Subject: Edward Mills Property – 5236 W Mercer Way Wetland Delineation Professional Opinion Concurrency Letter

This professional opinion concurrence letter provides a brief summary of our review of the wetland delineation and rating conducted by Red Wing Environmental at 5200 Block West Mercer Way, Mercer Island, Washington 98040 (Tax Parcel Number 192405-9324). PACE's scope includes preparing a professional opinion concurrence letter based on findings from an on-site review of the wetland delineation, conducting an independent review of the wetland rating using the Washington Department of Ecology 2014 rating system, commenting on any differences found in the delineation, data or rating, and commenting on the proposed buffer averaging and mitigation plan.

1. Wetland Buffer Mitigation Plan, dated 4/16/2018, produced by Mark Rigos, 440 SE Darst Street, Issaquah, WA 98027, 425.652.6013

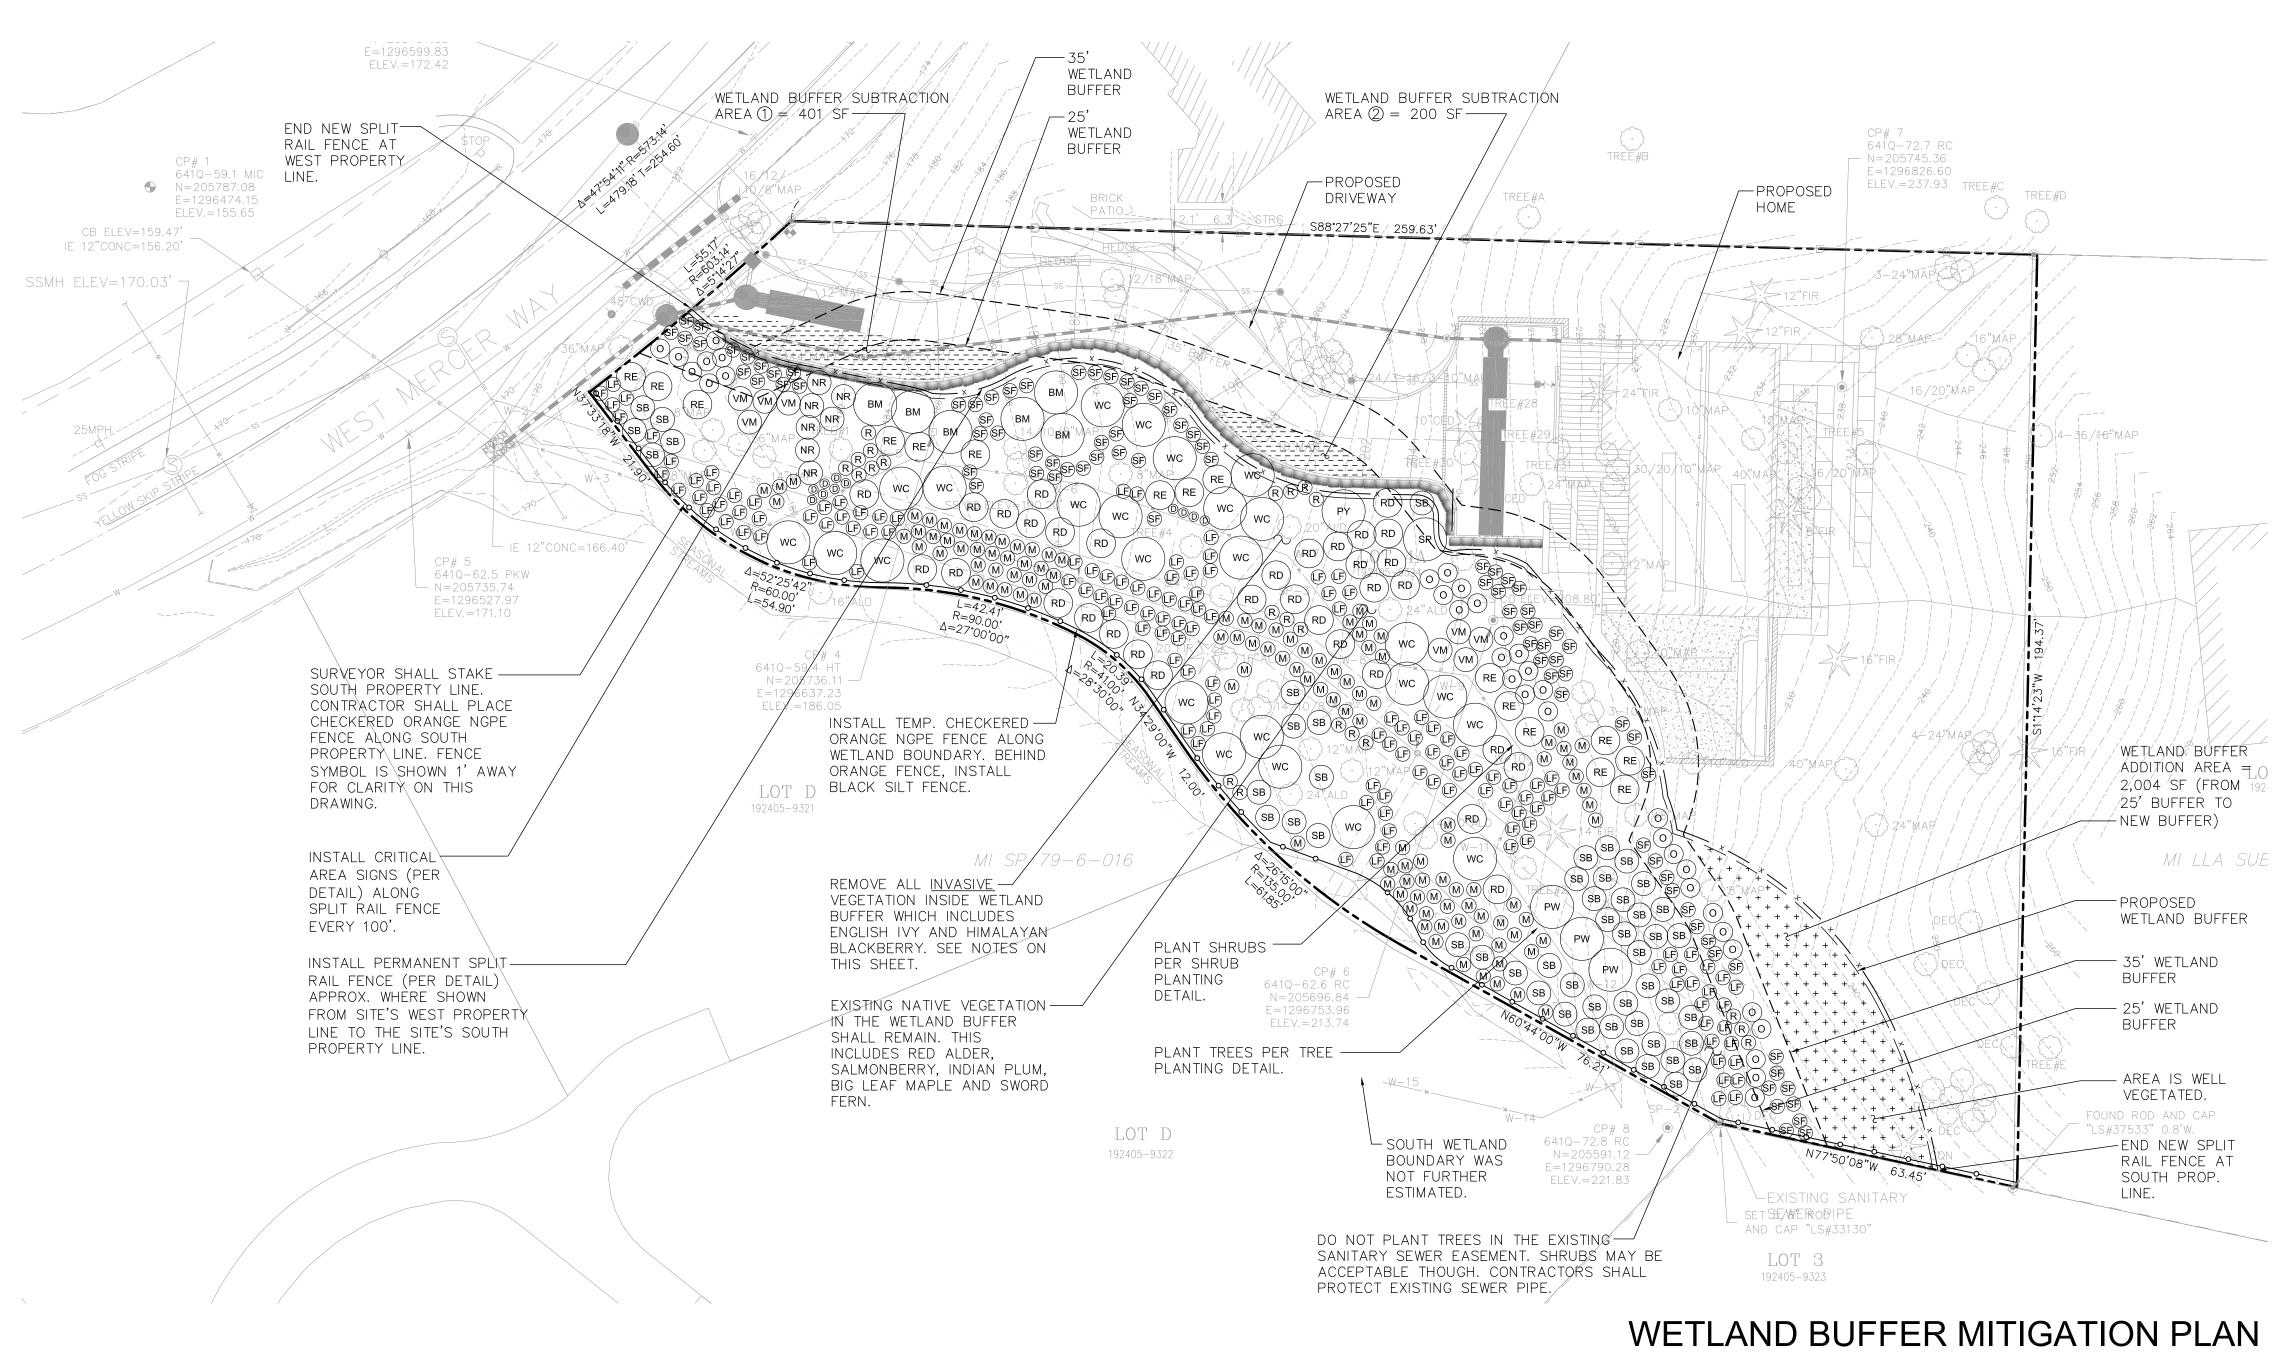
- The mitigation plan should be updated to include labels to better locate the wetland and the wetland buffer.
- The noxious and invasive weed removal areas should include both the entire wetland and buffer areas, to improve the chances of controlling these aggressive invasive non-native plants.

- The mitigation plan should include a table of figures to quantify the areas of buffer impact and the areas proposed for mitigation to provide analysis of no net loss.

- Existing trees should be better shown to help show where new plantings are proposed and to show that crowding won't be a problem

- The Critical Areas sign on the plan is for King County.
- On Sheet W1.0, the note stating, "*Area is well vegetated*", the existing vegetation is not shown or identified.

- On Sheet W1.0, the note stating, "*End new split rail fence at south prop. Line*", appears to point to the orange checkered NDPE fence.
- The Legend lists temporary shoring, which is not visible on the plan, wetland flags, which are also not visible on the plan, and sample point Flag #s, also not visible on the plan. Recommend that these items be removed from the legend or made visible on the plan sheet.
